Access Compliance Report

Public Rights-of-Way

Intersection ID: 6060	Main Street: FAIRES_FARM_RD	Cross Street: JOSIE_ST	Location:	N
ADA ID: 58FC5153CC7A	Ramp Type: Perp	Initial Pass/Fail: Fail	Overall Compliance: No	Severity Score: 10
Codes/Mitigation Info/Possible Solution		Field Measurements/Component Compliance

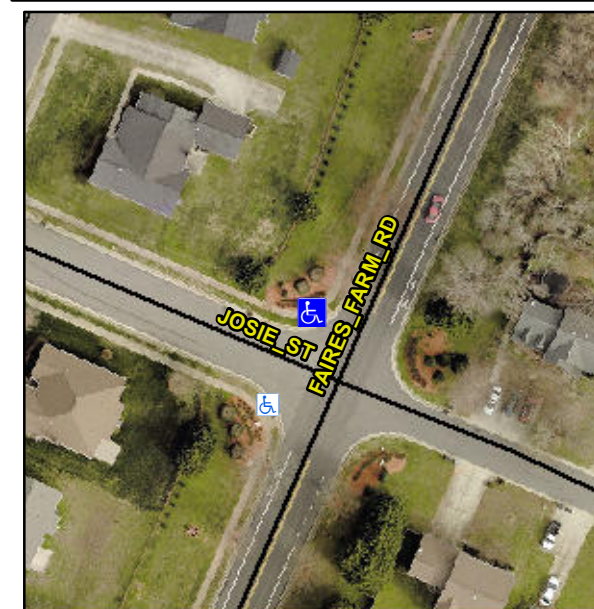
Not Found, R304.5.1, R304.5.3

Compliance	Description	Data	Compliance	Description	Data
N/A	Ramp Length (in)	47.5	Yes	Ramp Slope (%)	6.0
No	Ramp Width (in)	47.5	No	Ramp XSlope (%)	3.9
N/A	Flare Type LT	N/A	N/A	Flare Type RT	N/A
N/A	Flare Slope LT (%)	N/A	N/A	Flare Slope RT (%)	N/A
N/A	Flare Traversable LT?	N/A	N/A	Flare Traversable RT?	N/A
N/A	Landing Length (in)	N/A	N/A	DWS Provided?	N/A
N/A	Landing Width (in)	N/A	N/A	DWS Contrast?	N/A
N/A	Landing Slope (%)	N/A	N/A	DWS Length (in)	N/A
N/A	Landing X Slope (%)	N/A	N/A	DWS Full Width?	N/A
N/A	Landing Curb? (Y/N)	N/A	N/A	DWS Offset (in)	N/A
N/A	Shared Landing?	N/A			
N/A	Gutter Ponding?	N/A	N/A	Gutter Slope (%)	N/A
N/A	Gutter Lip Ht (in)	N/A	N/A	Gutter X Slope (%)	N/A
N/A	Painted X Walk1?	No	N/A	Painted X Walk2?	N/A
	X Walk 1 Direction	To W		X Walk 2 Direction	N/A
N/A	X Walk 1 Width (in)	N/A	N/A	X Walk 2 Width (in)	N/A
	X Walk 1 Slope (%)	4.3		X Walk 2 Slope (%)	N/A
	X Walk 1 X Slope (%)	0.2		X Walk 2 X Slope (%)	N/A

Remove & Replace Entire Ramp.
